Air Top 3500/5000 Burner Replacement Kit

08-10-2000 rev. 5/2015

Improved Burner Chamber and Burner Tube for the Air Top 3500 / 5000 Heaters

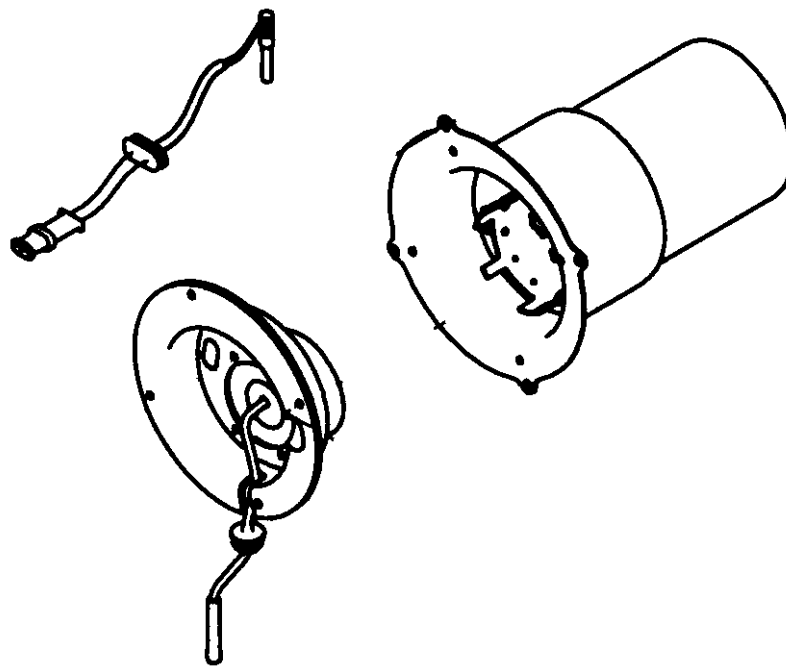
A manufacturing change to the Air Top 3500 and Air Top 5000 burner chamber and burner tube begins 12/99. This enhancement reduces the thermal load on the ceramic igniter effectively increasing the life span of the igniter.

To perform this modification, it is necessary to replace the burner chamber and burner tube. For this purpose, we have developed two burner upgrade kits, one for 12 volt units and one for 24 volt units.

12 Volt Upgraded Burner Kit	67984
24 Volt Upgraded Burner Kit	1322862
Workshop Repair Manual	63380
